ZF = 1465

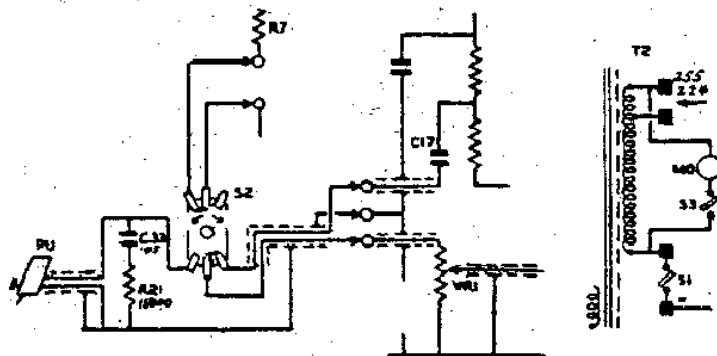
The above diagram shows the differences to the circuit for the radiograms and autoradiogram. On the latter models C14 is deleted. The resistance R21 and condenser C33 are mounted on the Radio-Gram switch S2 a practical diagram of which is shown.
